**INDIANA DEPARTMENT OF ADMINISTRATION**  
**PUBLIC WORKS PROJECT NUMBER ENG2402889284**  
**NASBY DAM REHABILITATION**  
**PIGEON RIVER FISH & WILDLIFE AREA**

**Addendum No. 1**

**Issue Date: Tuesday, January 16, 2024    Bid Date: January 23, 2024**

1. Clarification – Project Number is **ENG2402889284**
2. Pre-bid Meeting notes and sign-in sheet
3. Two (2) Replacement plan sheets – page 2 of 22 and page 3 of 22
4. Replacement sheet in detailed specifications – DS-10 (Work Item 4 – Dewatering & Protection of Existing Structures).

INDIANA DEPARTMENT OF  
 NATURAL RESOURCES  
 NASBY DAM REHABILITATION  
 STAGING AND SITE ACCESS

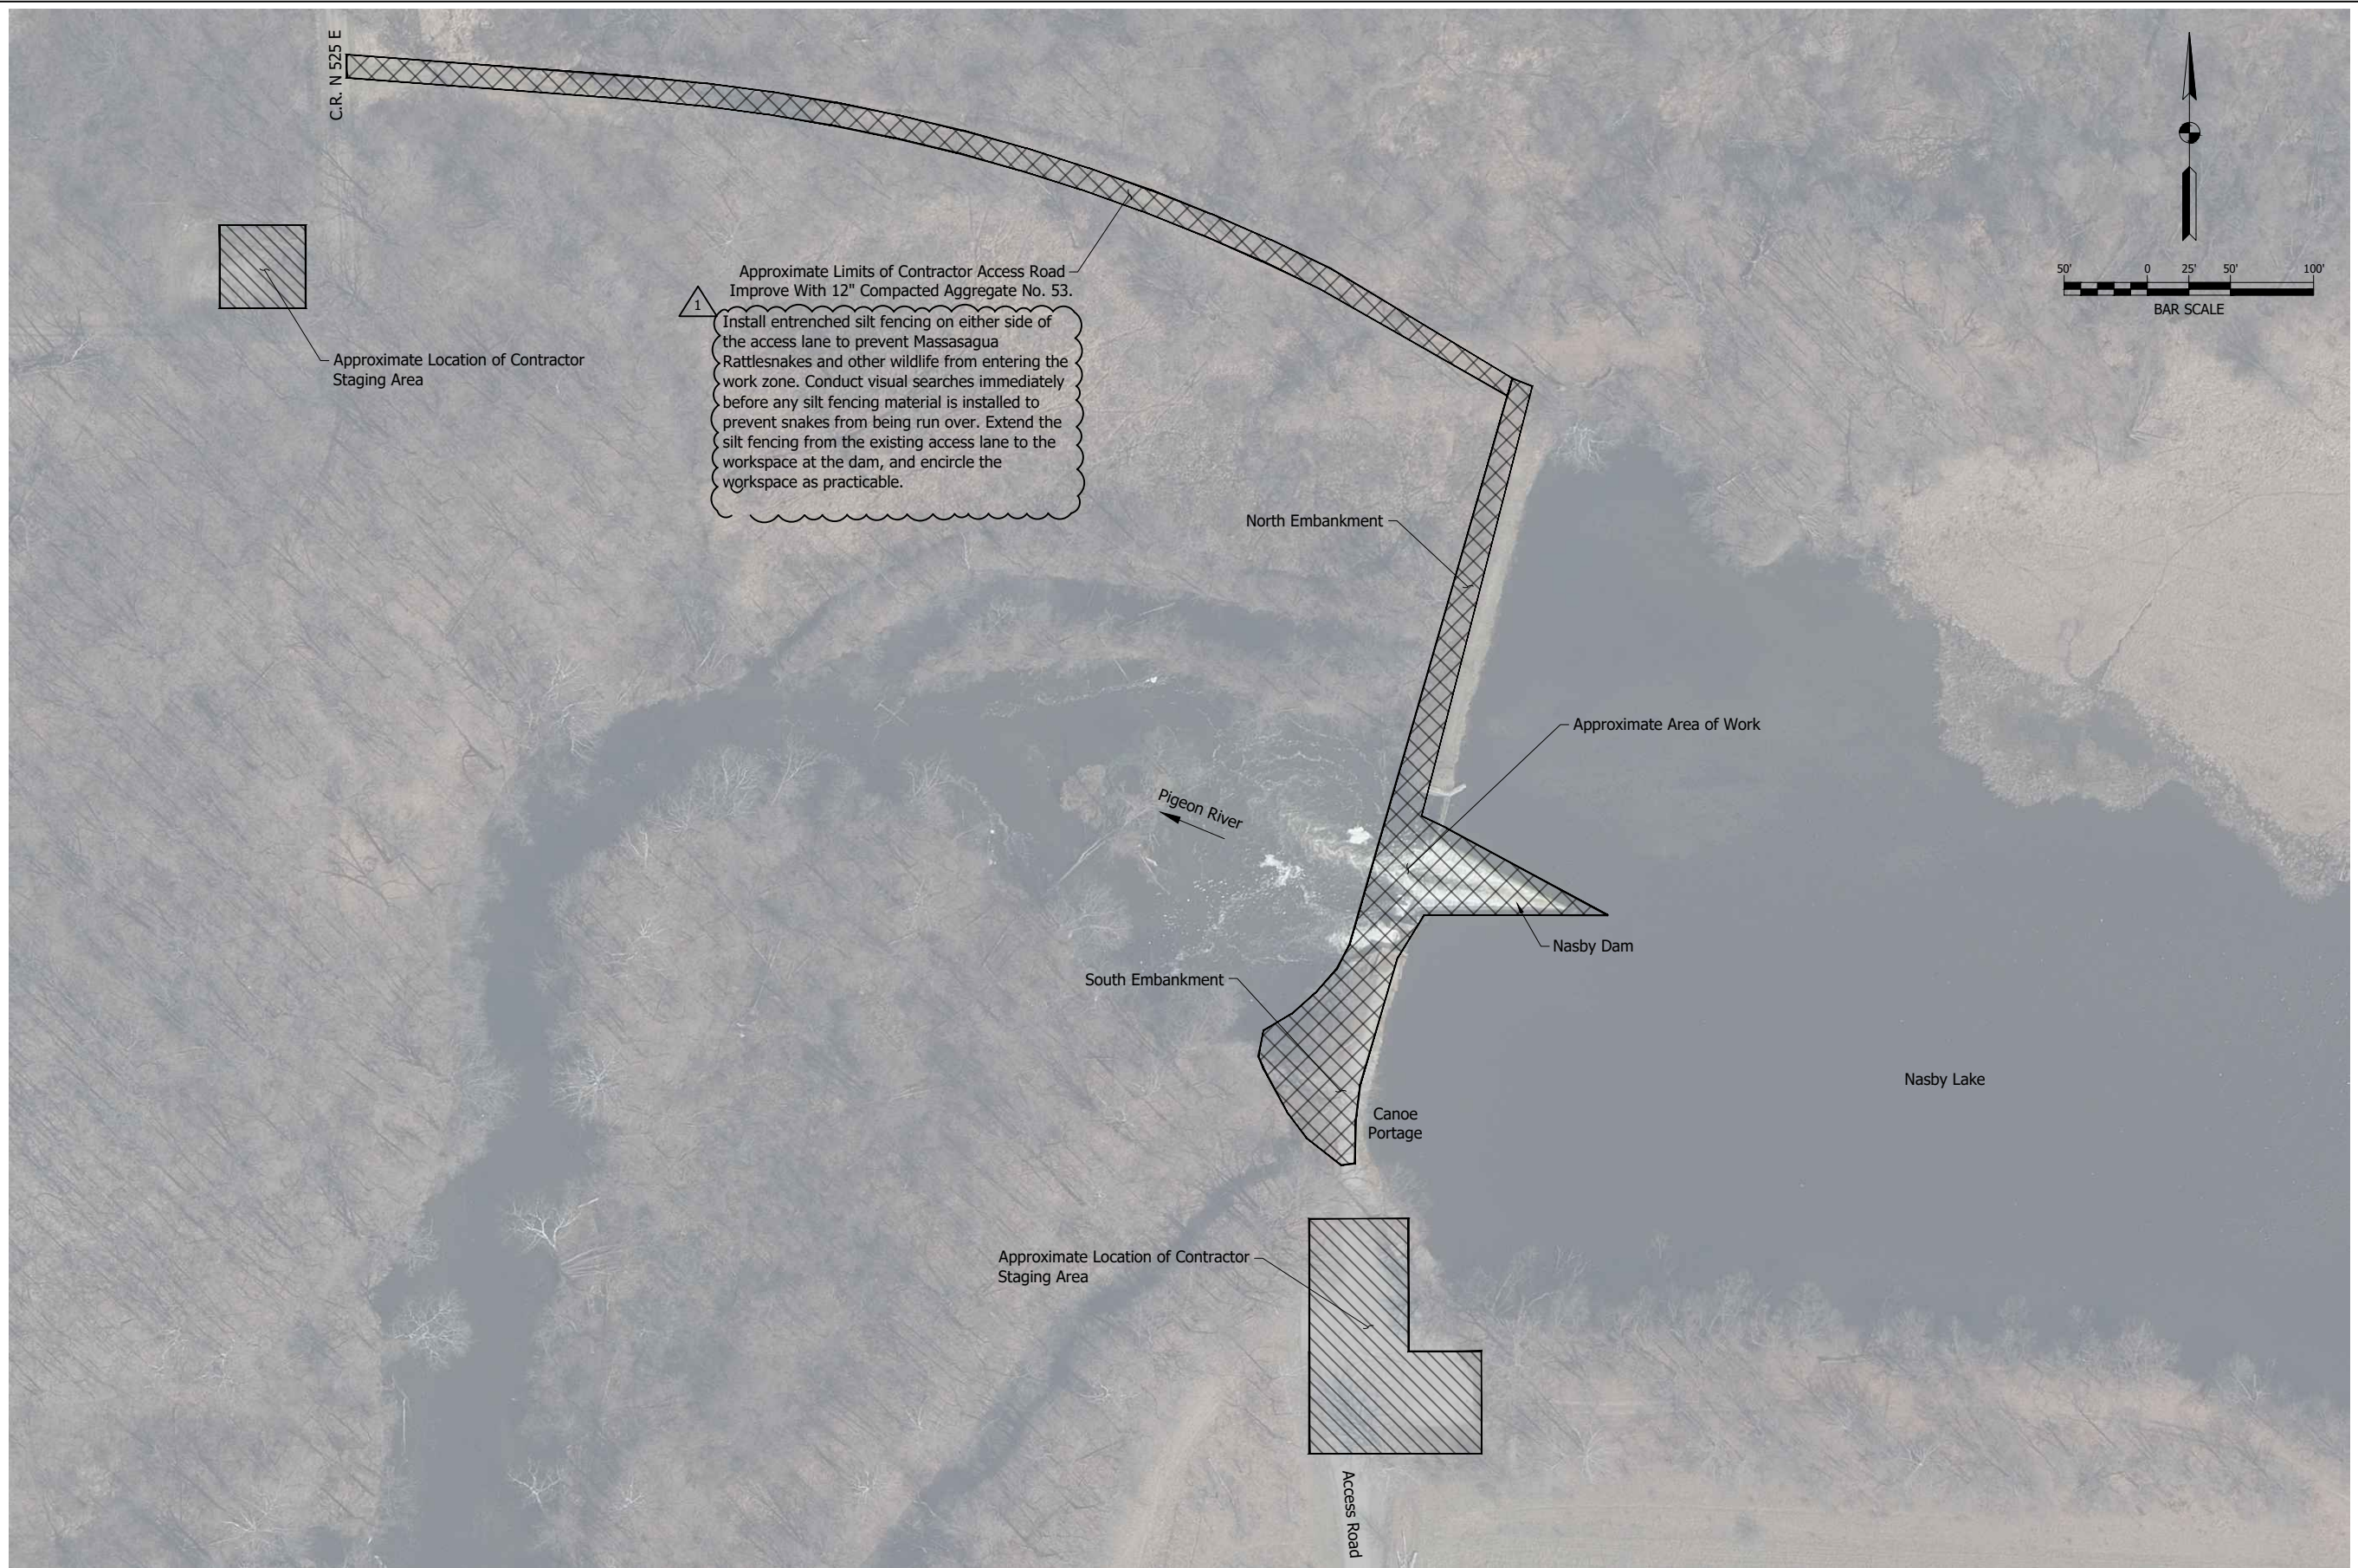
- c. Staging area is shown on the plans and access road must be improved per the plans. (After the pre-bid meeting the IDNR Construction in a Floodway permit was issued requiring the installation of entranced silt fencing on either side of

the access lane to prevent Massasauga Rattlesnakes and other wildlife from entering the work zone. Conduct visual searches immediately before any silt fencing material is installed to prevent snakes from being run over. Extend the silt fencing from the existing access lane to the workspace at the dam, and encircle the workspace as is practicable.)
